November 1, 2022

ADDENDUM 2

Walnut Valley Unified School District
Diamond Bar High School
Building 400 Modernization New Classrooms/Library Media
DSA #03-121330 | File #19-H52

21400 PATHFINDER RD. DIAMOND BAR, CA 91765

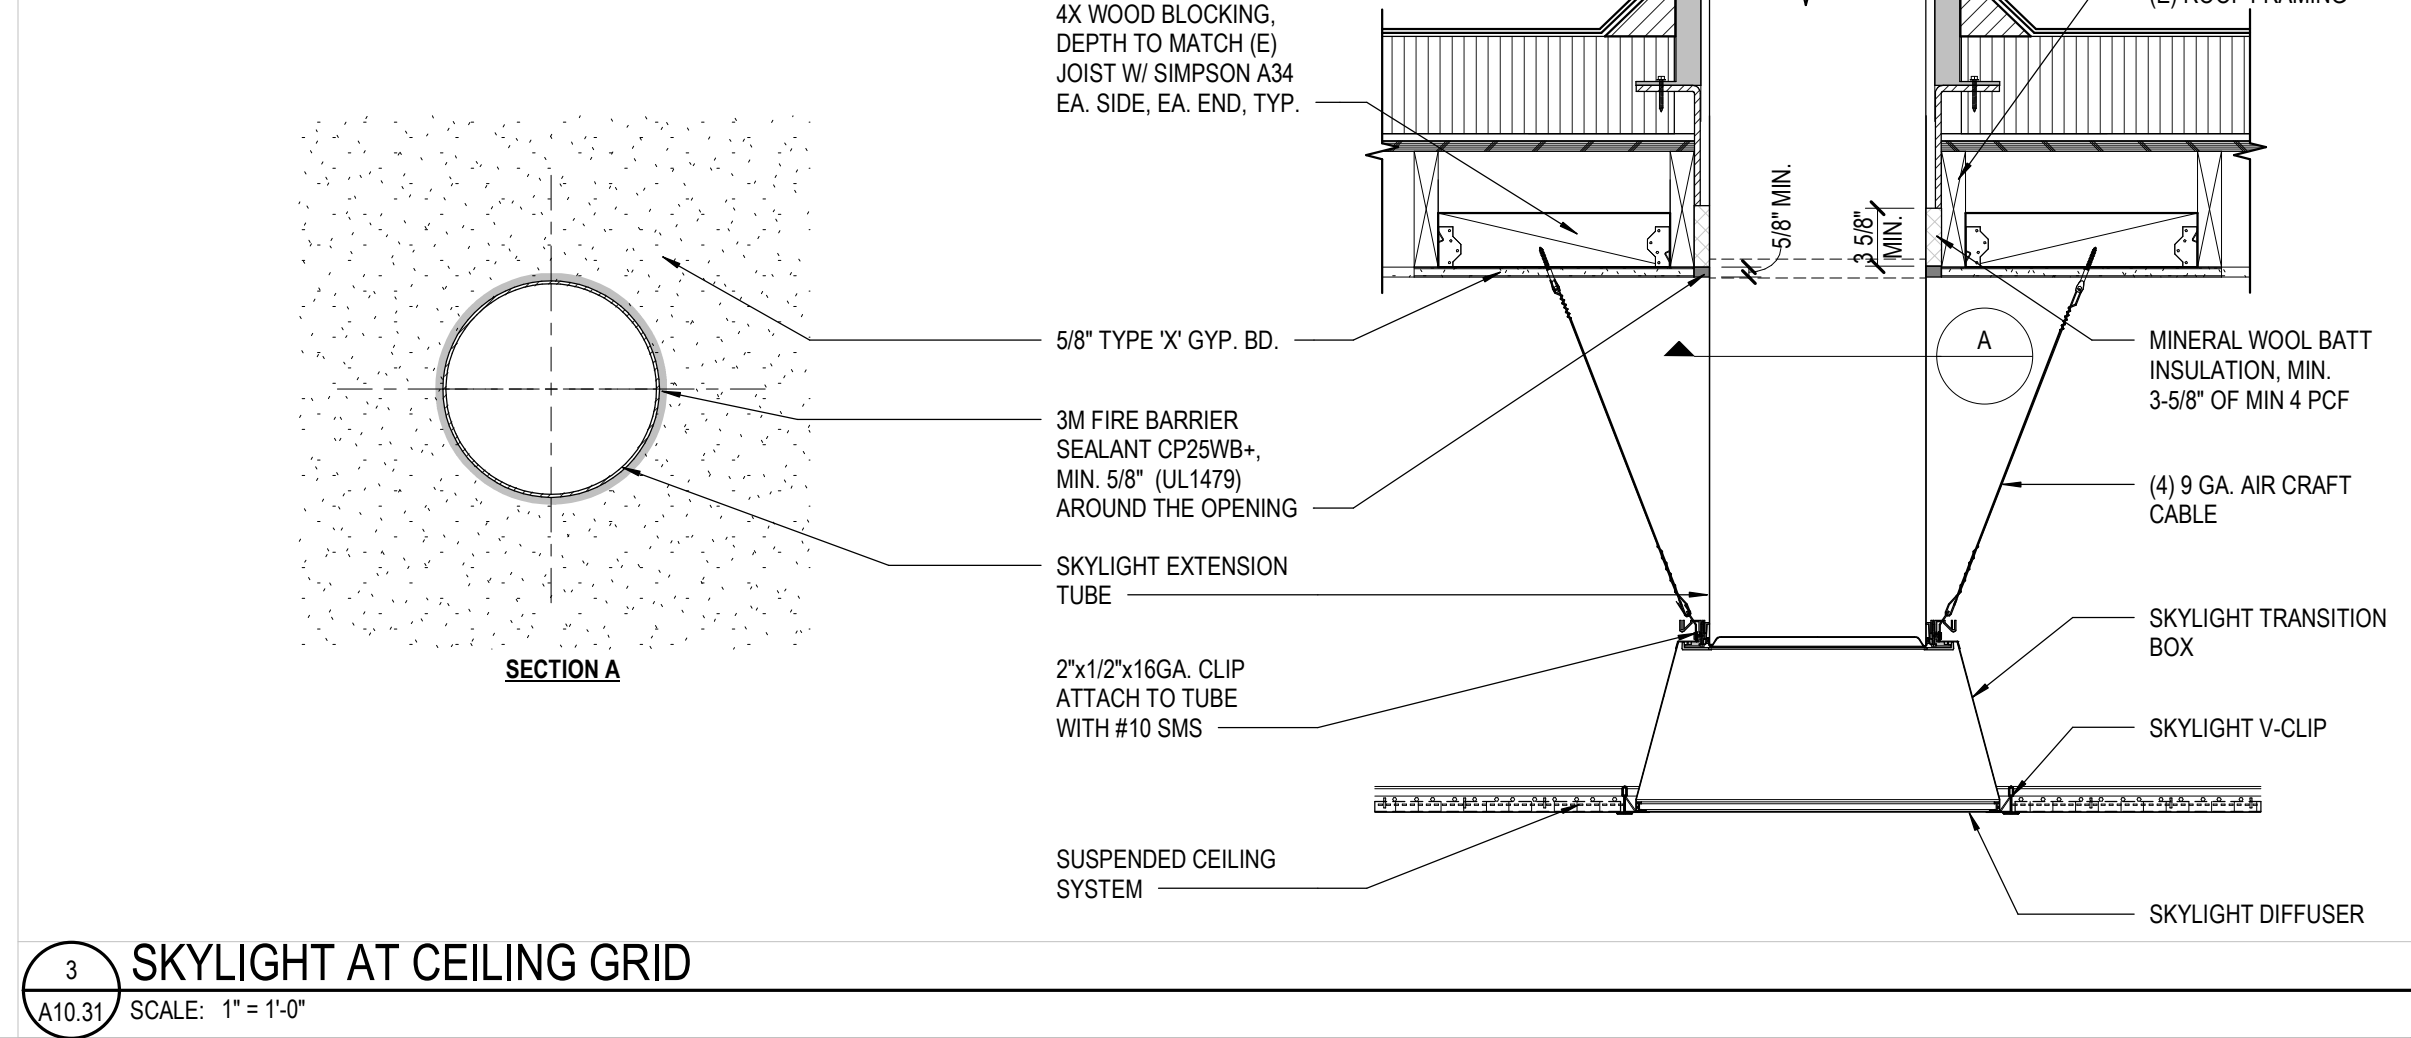
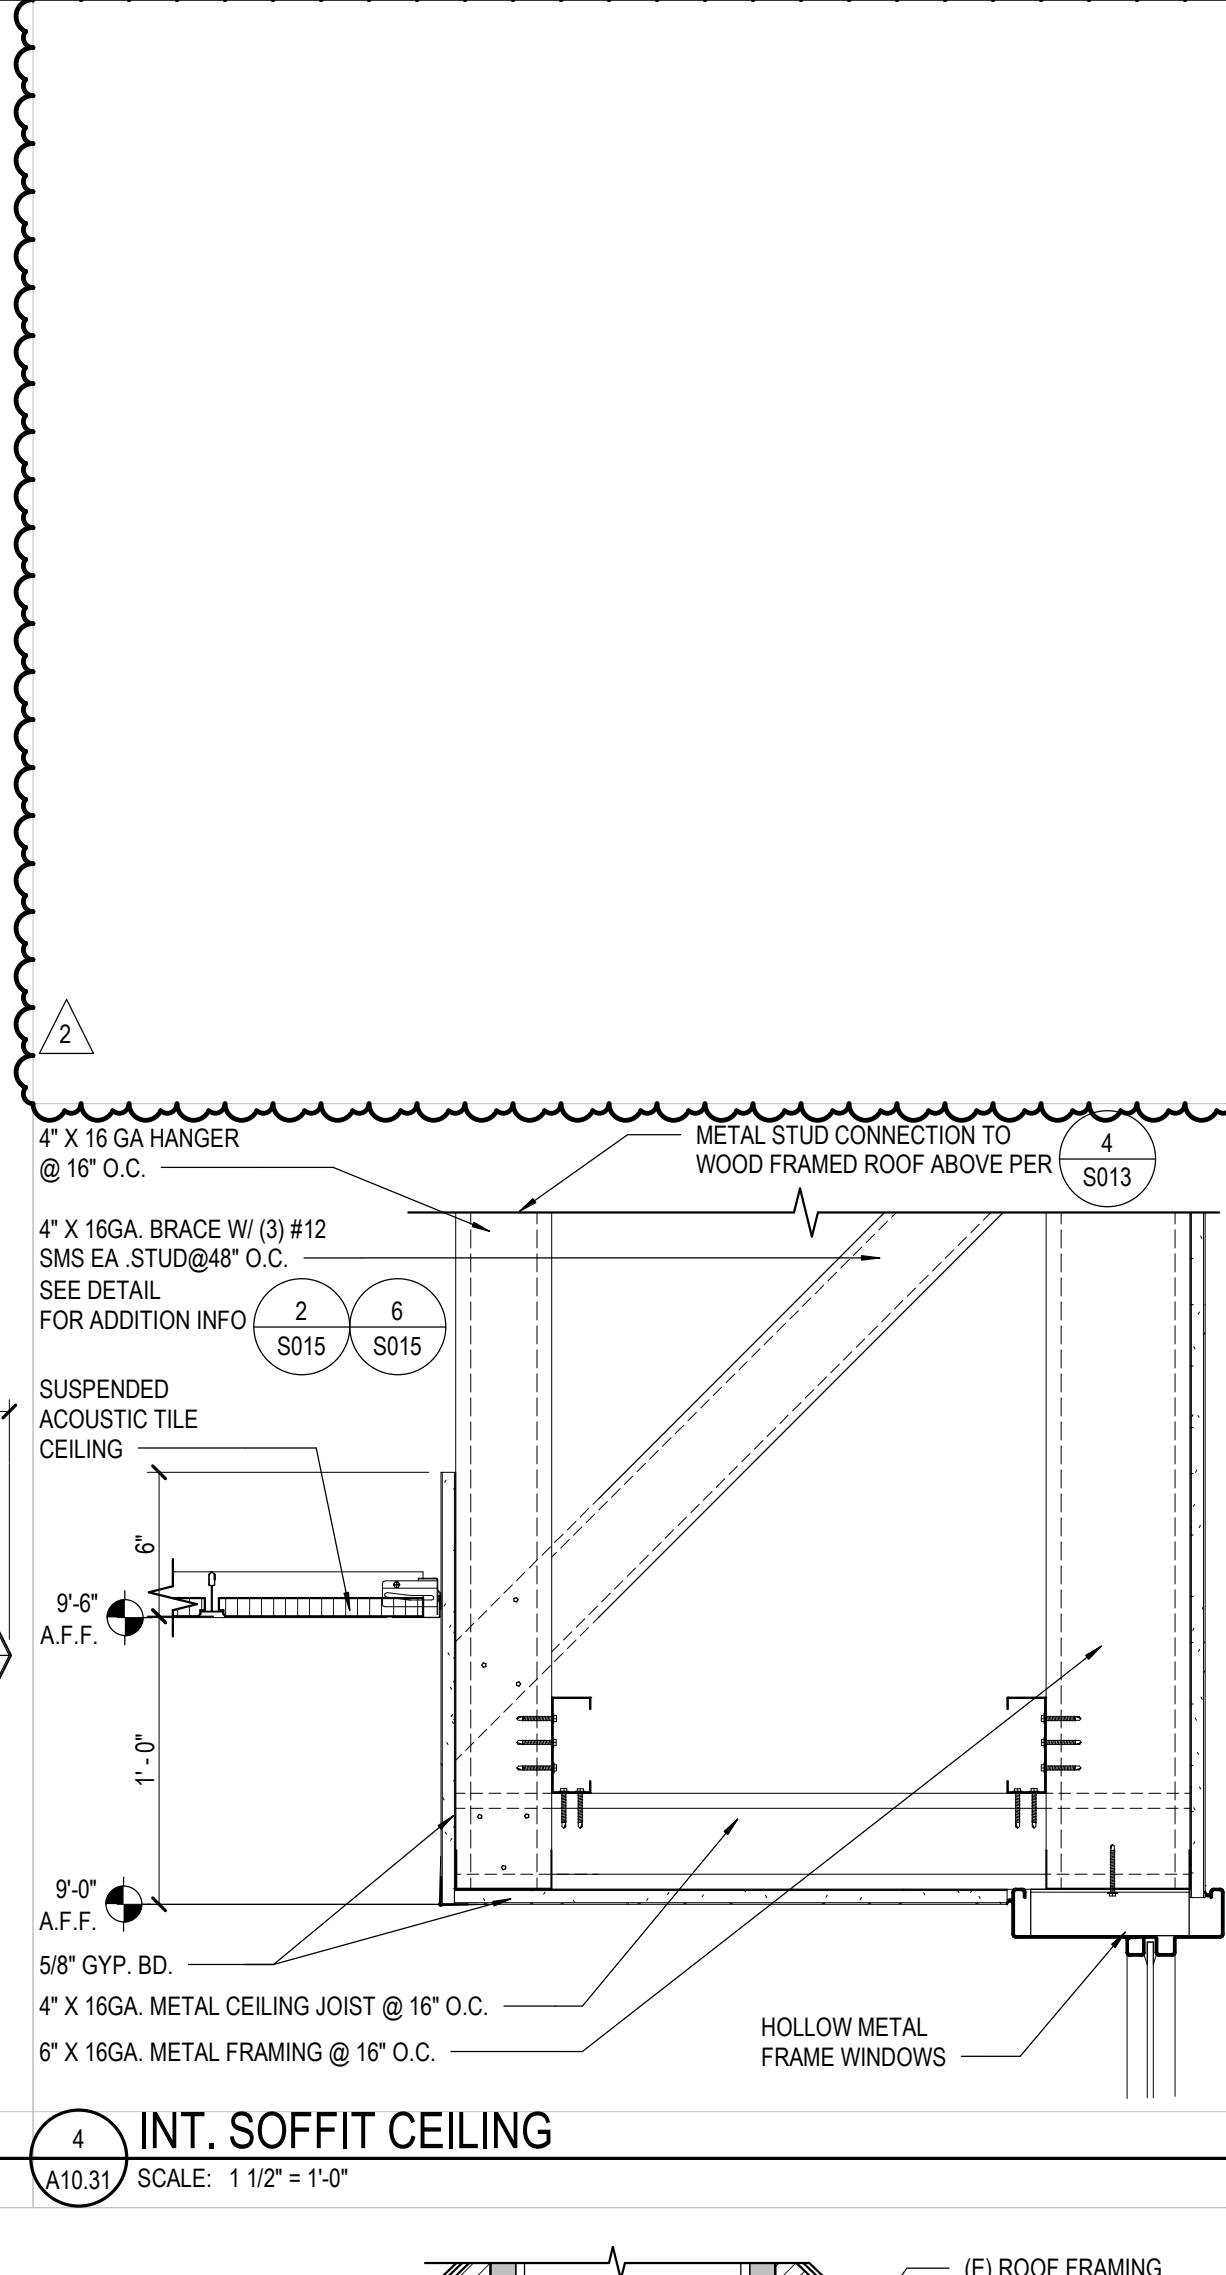
A10.11 INTERIOR DETAILS

- A. 23/A10.11: EDITED DETAIL TO DELETE THE HAND DRYER WHICH IS NOT USED IN THIS PROJECT
